Midway City Council  
20 July 2021  
Work Meeting

Resolution 2021-13 /  
Street Cross-Sections

**To: Mayor Johnson and City Council**  
**From: Wes Johnson**  
**Date: July 16, 2021** **Memorandum**  
**Subject: Memo Regarding Midway City Standard Roadway Widths**

### **A RESOLUTION BY THE MIDWAY CITY COUNCIL ADOPTING AN UPDATED STANDARD SPECIFICATIONS AND DRAWINGS FOR THE CITY OF MIDWAY**

**LOCAL STREET CROSS SECTION #1  
COMMERCIAL & BUSINESS**

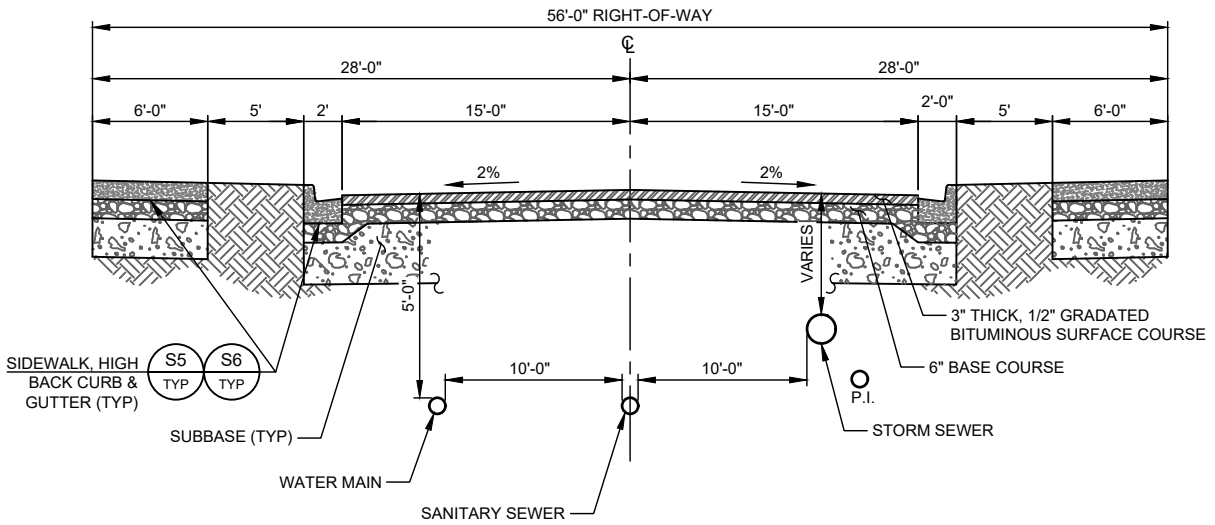
1. Local Street Cross Section #1 for Commercial Business
  - a. It is proposed to leave the asphalt cross section as shown. This will accommodate parking and allowing vehicles to open doors without causing issues for cars driving on the street.

**LOCAL STREET CROSS SECTION #2**

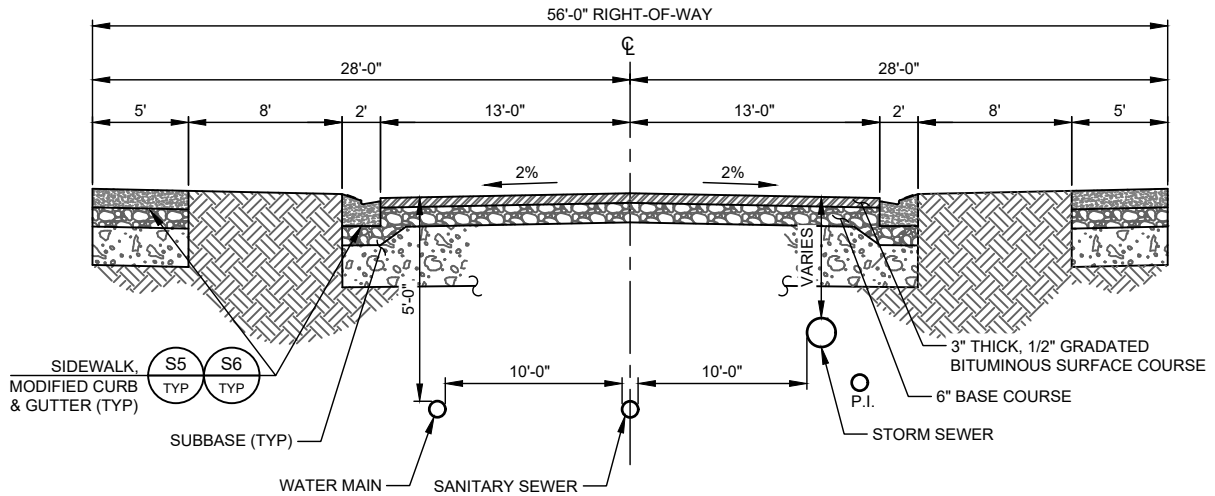
2. Local Street Cross Section #2
  - a. Reduce the required cross section width of asphalt from 30' to 26'.
  - b. Take the reduction in asphalt width and add it to the park strip. This would take the park strip from 5' wide to 7' wide.

LOCAL STREET CROSS SECTION #3

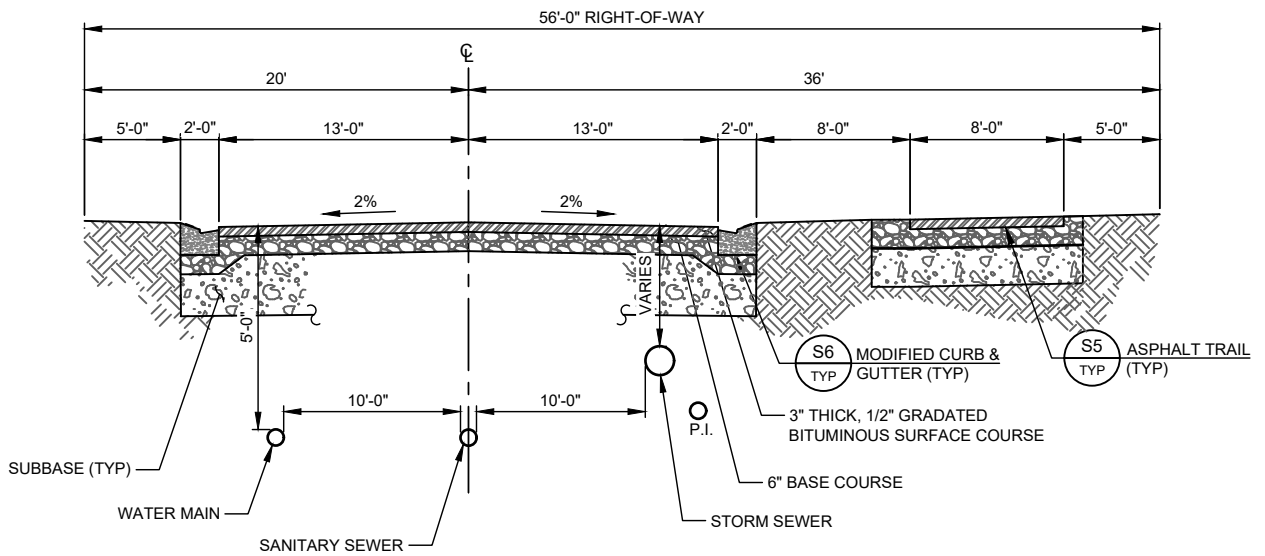
3. Local Street Cross Section #3
  - a. Reduce the required cross section width of asphalt from 30' to 26'.
  - b. Take the reduction in asphalt width and add it to the park strip.

- c. With a only a trail on one side of the road.
  - d. The road is shifted to the left so that the left side of the cross-section distance from the curb and gutter to the ROW equals the right-side distance of the outside edge of the trail to the ROW.

**LOCAL RURAL STREET CROSS SECTION #4**

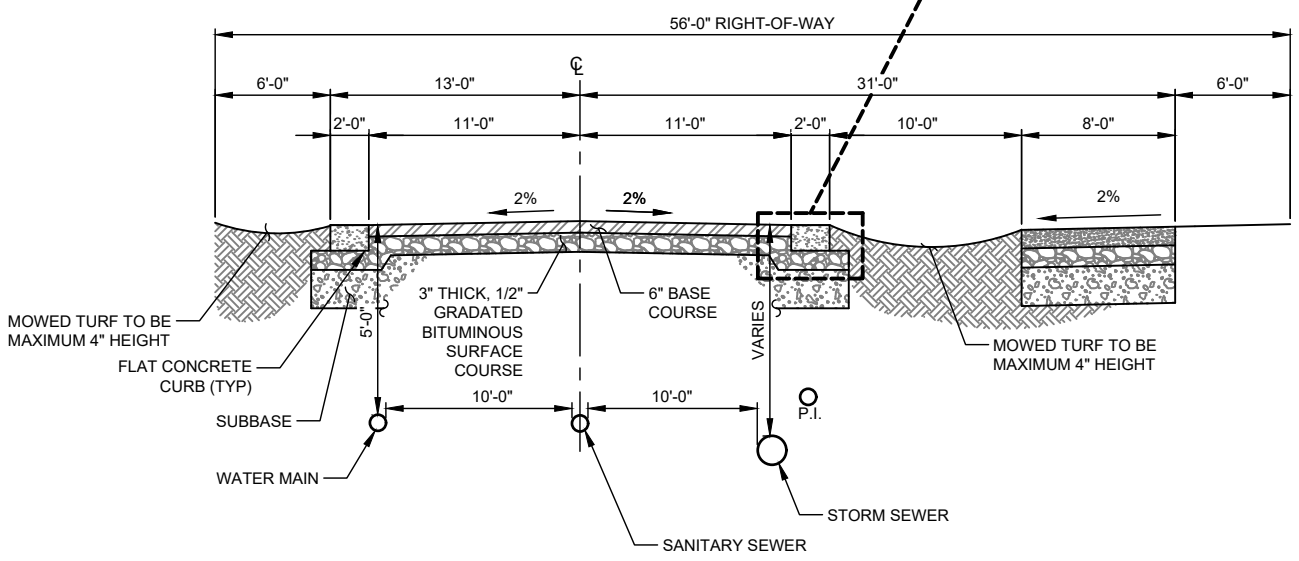
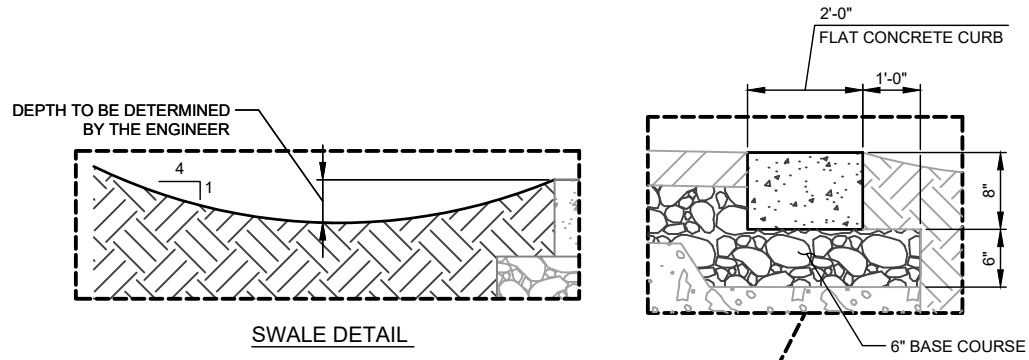
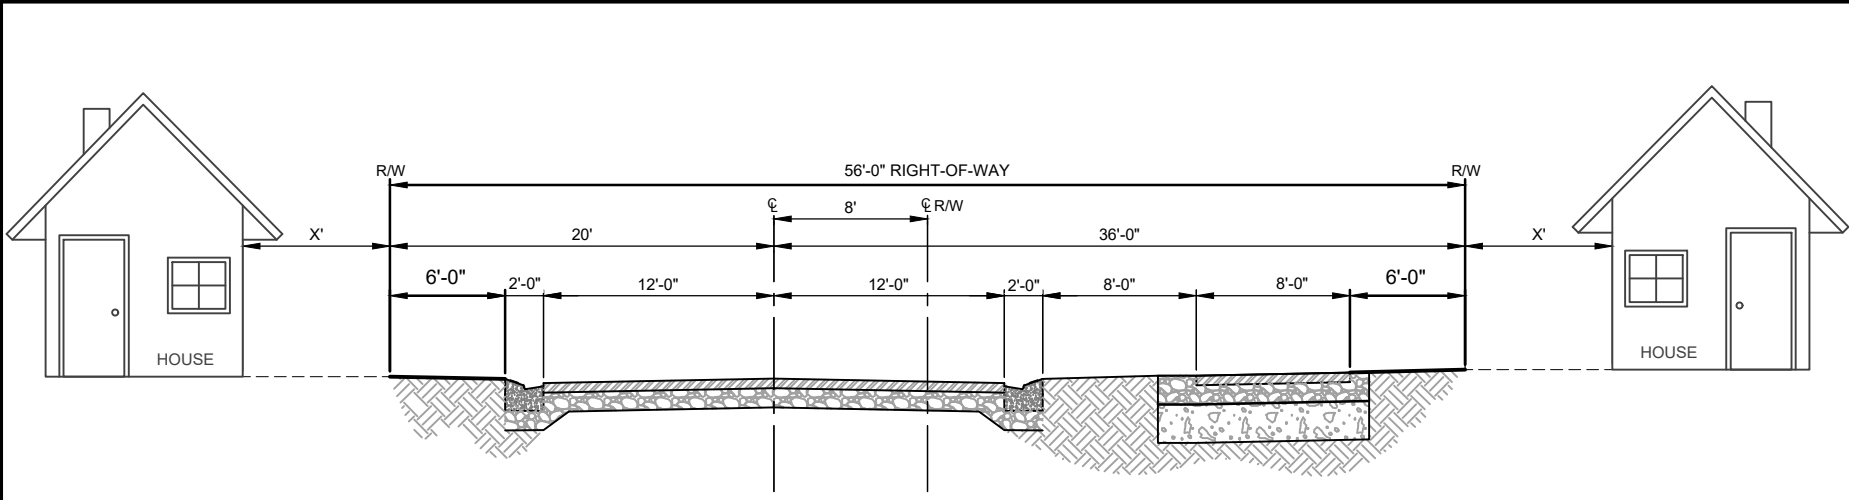
We met with Councilmen Simons, Councilmen Payne, and the planning staff regarding the Midway City standard roadway widths. The engineering department supports the proposed changes however our recommendation for local rural street asphalt cross section be increased from 20' to 22' of asphalt. Below is a summary of our discussion with the attached cross sections:

4. Local Rural Street Cross Section #4
  - a. To qualify for this cross section the frontage requirement has been reduced from 150' to 105' and must be approved by City Council.

- b. Reduce the required cross section width of asphalt from 30' to 20'. With a 2' ribbon curb on each side.
  - c. Take the reduction in asphalt width and add it to the park strip.

- d. With a only a trail on one side of the road.
  - e. The road is shifted to the left so that the left side of the cross-section distance from the curb and gutter to the ROW equals the right-side distance of the outside edge of the trail to the ROW.
